# TDFOM simplification proposal

Rubén Pérez-Aranda, KDPOF  
David Leyba, Keysight

## BASE-AU 980nm/OM3 reference receiver and analysis

# New TDFOM

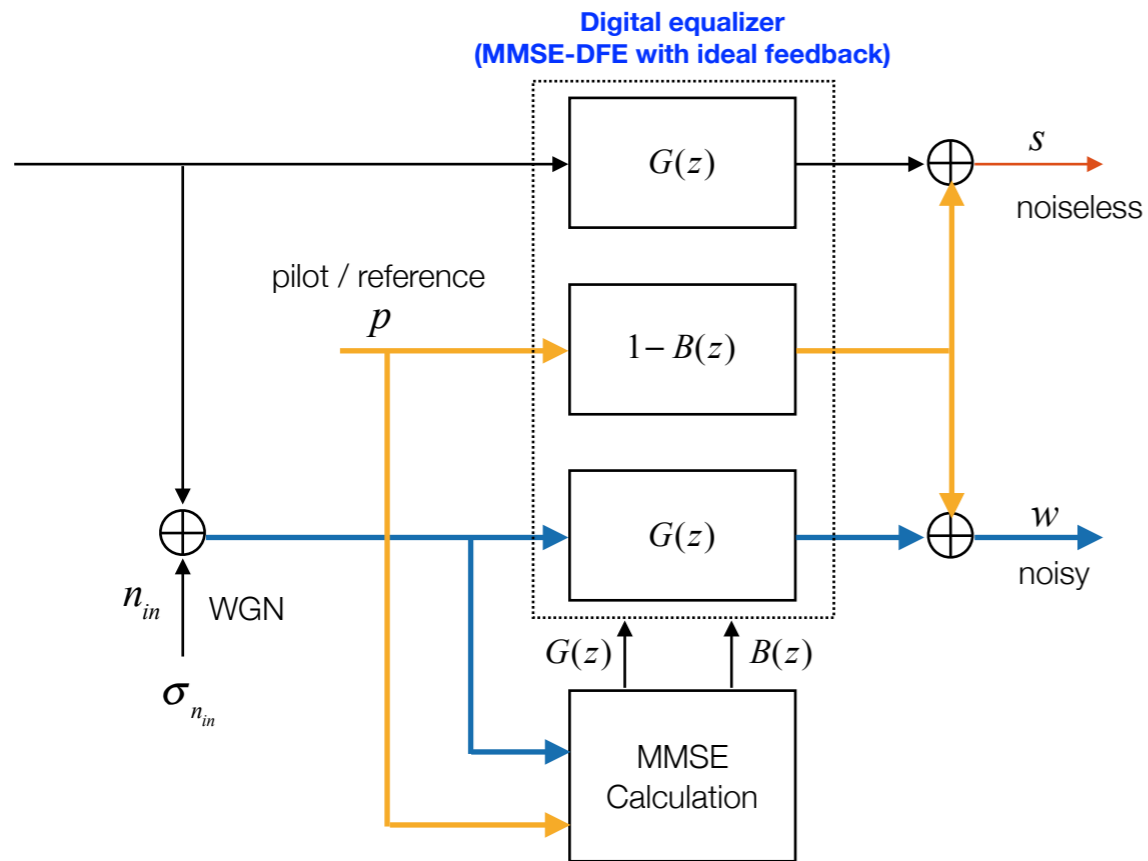
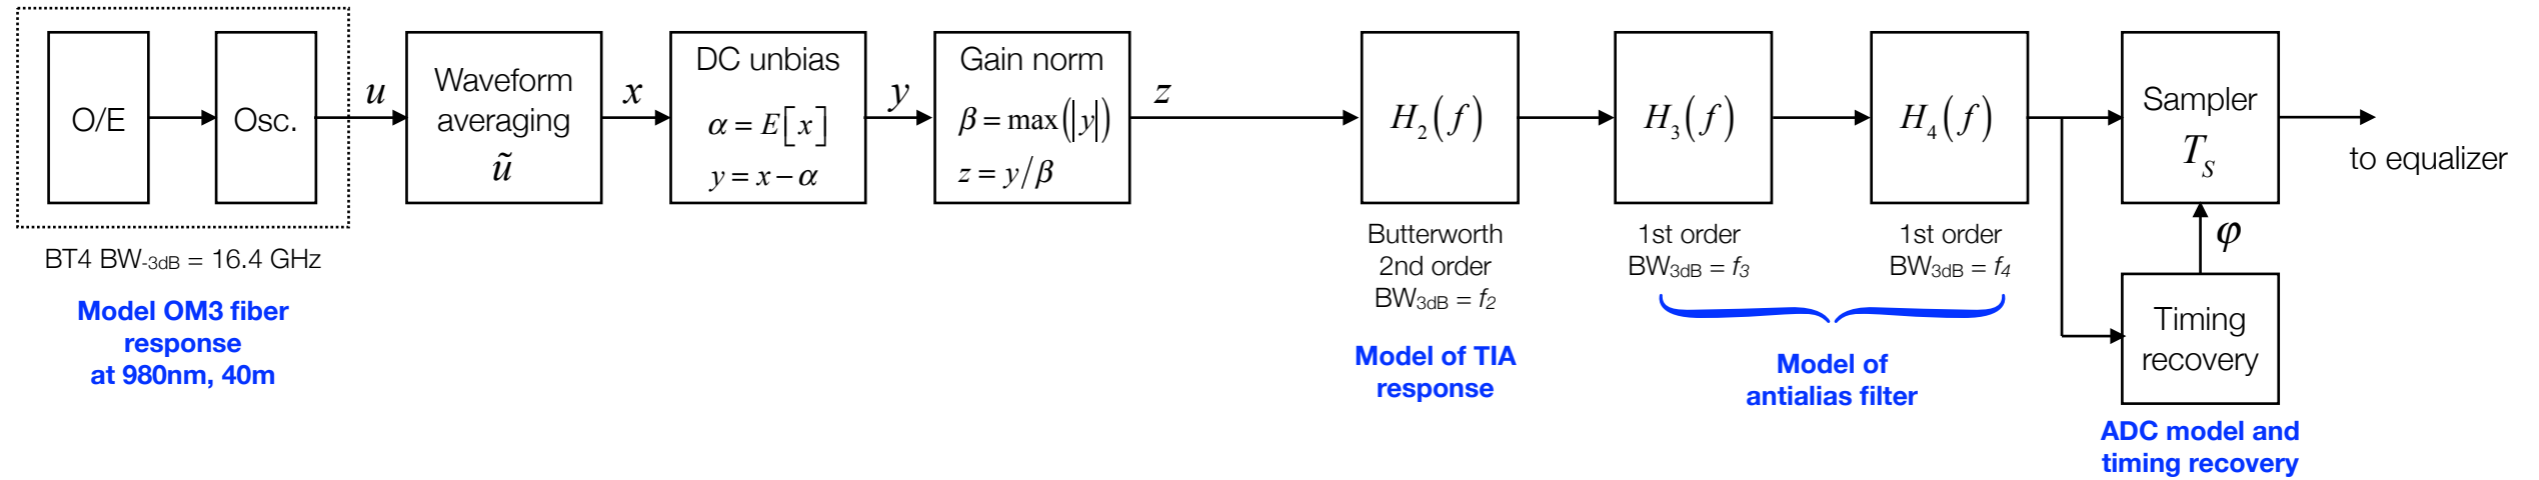
- This contribution proposes a simplification of the TDFOM reference receiver and figure of merit of [1]
- Simplification is addressed in several ways:
  - Added noise is white, so noise filter is removed
  - Noise is added at the sampler output, so analytical calculation of standard deviation after equalizer is direct (noise variance measurement is removed)
  - Because noise is added at sampler output, the dependency with oversample factor (samples per UI) is also removed
- Improvement in OMA calculation for PAM4 is also proposed
  - CID length and pre/post cursors lengths is updated according to SSPR-PAM4 pattern
- New TDFOM proposal has been validated vs OMA receiver sensitivity

# H1 is removed

- The input low pass filter shall be 4<sup>th</sup> order Bessel-Thomson with  $BW_{-3dB} = 16.4$  GHz
- Acquisition oversampling (samples per unit interval) shall be,  $O_v > 15$
- Waveform averaging shall be enabled to eliminate noise; averaging factor shall be selected high enough to avoid noise affecting the TDFOM analysis (error below 0.05 dB)
- Filters shall be scaled according to symbol period and modulation format as:
